<b>GROUP</b> <b>Safety Recall Campaign</b>	<b>MODEL</b> <b>2014MY Forte (YD) w/1.8L and 2.0L Engines</b>
	<b>NUMBER</b> <b>SC 113</b>	<b>DATE</b> <b>February 2014</b>
<b>VOLUNTARY SAFETY RECALL CAMPAIGN</b>		
<b>SUBJECT: COOLING FAN RESISTOR AND/OR MULTI-FUSE UNIT REPLACEMENT (SC 113)</b>

**SUBJECT:** COOLING FAN RESISTOR AND/OR MULTI-FUSE UNIT  
REPLACEMENT (SC 113)

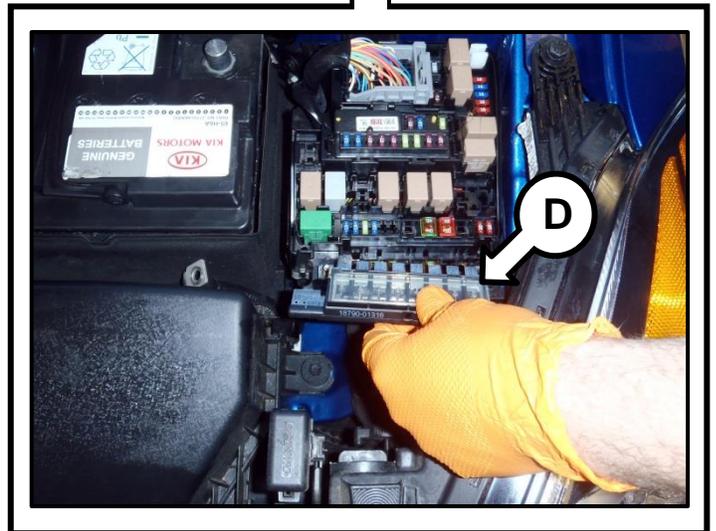
6. Remove and replace the multi-fuse unit (D) with an improved part, when applicable.

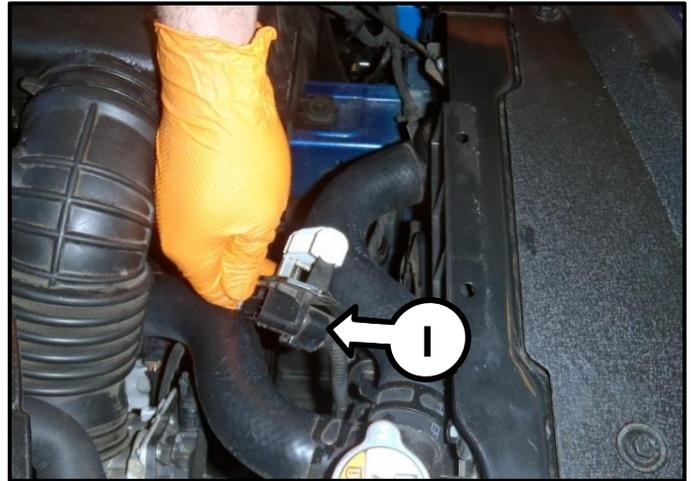
12. Install the improved cooling fan resistor, when applicable, by reversing the order removal.
13. Reinstall all other removed components by reversing the order of removal.
14. Reconnect the negative (-) terminal to the battery.
15. Restore the customer's radio presets as recorded in step 1.
